INSPECTION REPORT OF 330KV SWITCHING STATION AT IKOT EKPENE, AKWA IBOM STATE

INSPECTION REPORT: 330KV SWITCHING STATION

Uncovered drain pipes

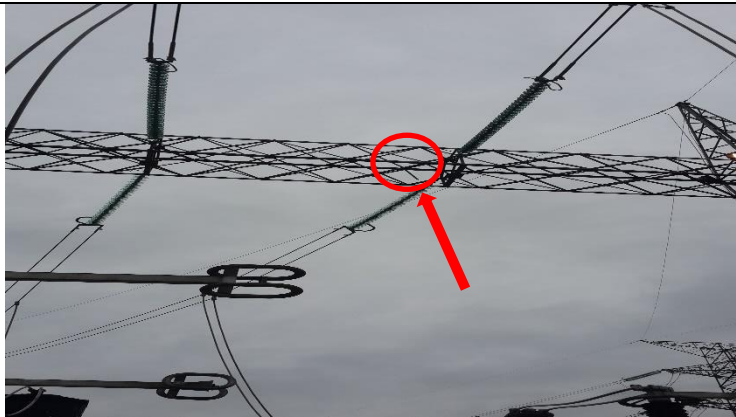
S/No	PROJECT AREA	OBSERVATIONS	PICTURES	RECOMMENDATIONS
1.	SWITCHYARD	<p>1. The Switch Yard has perimeter fencing with wire mesh adequately earthed at different points.</p> <p>2. The switchyard was well graveled and leveled.</p> <p>3. Drainage system was provided to discharge water outside the switchyard, but some drain pipes not yet covered completely with granite.</p> <p>4. The cable trench slabs were not designed uniformly (unsafe), and there are portions of the trenches not covered.</p> <p>5. The CCTV poles in the switchyard were not earthed.</p> <p>6. Flood lights were provided.</p> <p>7. Water retention observed on the walkway.</p>	<div data-bbox="954 252 1507 691" data-label="Image"> </div> <p data-bbox="1529 288 1671 475">Switch Yard Perimeter wire mesh fencing</p> <div data-bbox="954 691 1507 1114" data-label="Image"> </div> <p data-bbox="1529 735 1648 963">Well levelled and graveled switch yard</p>	<p>1. The cable trench slabs should be uniformly designed and arranged for safety. Handles should be flattened to prevent operation personnel tripping over them.</p> <p>2. 36 missing cable trench covers should be provided</p> <p>3. The CCTV poles in the switchyard should be earthed.</p> <p>4. Passage should be made/provided for the water retained on the walkway.</p> <p>5. Granite should cover all drain pipes</p> <p>6. Broken/cracked concrete slabs should be replaced.</p> <p>6. The unfinished areas of wire mesh fencing should be completed.</p>

8. Adequate lightning protection seen; both spikes and sky wire lattice.
9. Some pvc pipes through which cables are run into the ground and cable trenches were seen not sealed.

7. The metal gates leading into the switchyard should both be earthed.
8. The surroundings of the switchyard should be kept tidy to avoid reptiles.
9. All pvc pipes through which cables are run into the ground and cable trenches should be sealed.

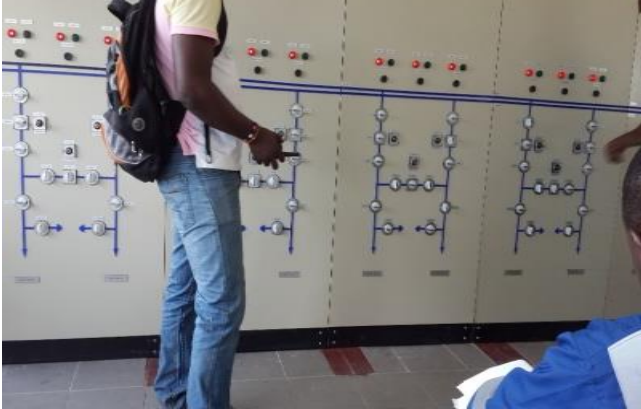
6.	EARTHING SYSTEM	<p>1. All the gantry legs were earthed at 2 points with 70mm² earth wire while hanging earth conductors were observed at D04 incoming Bay gantries (both legs) and D06 outgoing gantry.</p> <p>2. The earth readings obtained were between 0.10 and 2.01 Ohms. This is commendable. Full details of the earth readings are attached in</p>	 <p style="text-align: center;">Gantry leg earthing wire</p>	<p>1. The hanging earth conductors should be clamped properly to the gantries leg.</p> <p>2. All open earth pits should be covered with appropriate concrete slabs.</p>

<p>Appendix I. 3. The earth pit points were not covered.</p>		
<p>7.</p>	<p>CONDUCTORS /SPACERS</p>	<p>1. The conductor used observed to be ACSR. 2. Some protruding conductors were observed at various termination points 3. Some of the spacers and accompanying clamps were observed to be improvised, not well clamped/tightened around the conductors, and rusted bolts and nuts were seen used on the spacers. This has serious potential danger for arcing, melting of the conductors and eventual failure of the installation. 4. The conductor down-drops from the incoming lines to the lightning arrestors were seen not aligned properly and some seen were under strain</p>	<p style="text-align: center;">Improvised spacer</p>  	<p>1. The protruding conductors should be trimmed to flush at all termination points/ends. 2. The improvised spacers and clamps should be replaced with standard /specified type. 3. All the spacers not well clamped should be properly clamped and well tightened. 4. All conductors and terminations should not be under strain.</p>
